Re: Objections to St Leonards South rezoning SU5945

Yours sincerely
Resident,
Northwood
5 January 2018

[Note- See Attachments x 4; documents reproduced are as fair use for comment purposes: Markup of Levels x 1, Markup of E-W connection x 1, Extract markup of Council Gateway submission p3, Sixmaps 113m red dashed line across Newlands Park]

EXTRACT: COUNCIL "ORIGINAL REQUEST FOR CATEGORY 4"

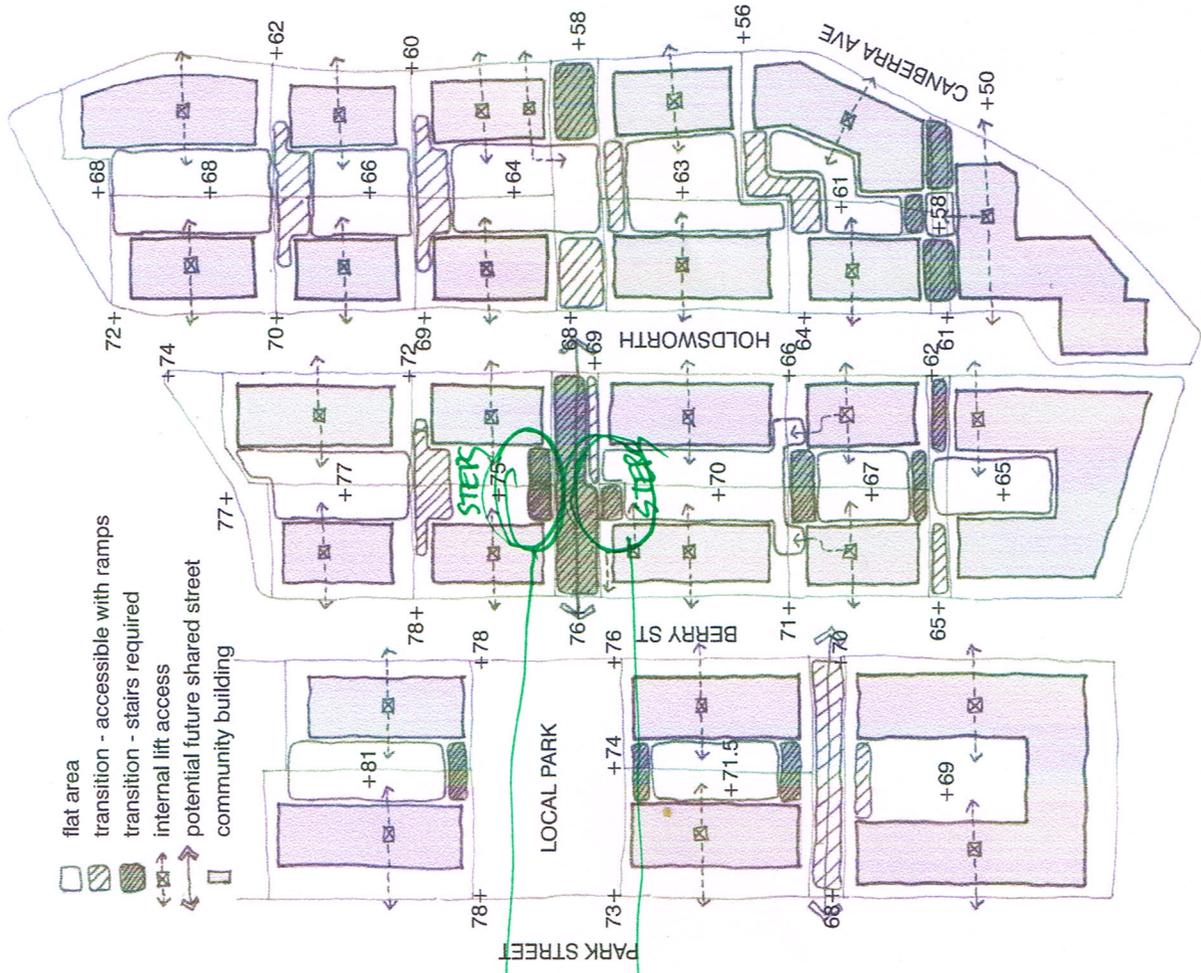
- The council's Original Request for Gateway on page 3 falsely stated a Visual Corridor would link the new western park with Newlands Park; the red mark-up on the accompanying extract of this pedestrian link shows that it is false – see mark-up attached.
8. North South connectivity links, ambitiously called “Green Spines” will not live up to expectations, once real-world level changes are considered in the design instead of hiding them in flowery drawings. These level changes will eat into the so-called green space. See mark-ups attached where pedestrian E-W link fails to show the steps to levels of the N-W green spine, both above and below the E-W links.
 9. The LEP Incentives chart is not a reliable document and should be withdrawn.

*
THIS
VISUAL
CORRIDOR
IS A
FABRICATION
— SEE
SIGHT LINE
TO NEWLANDS
PARK DRAWN
ON OCVLUS'S
E-W
ACCESSIBLE
SECTION
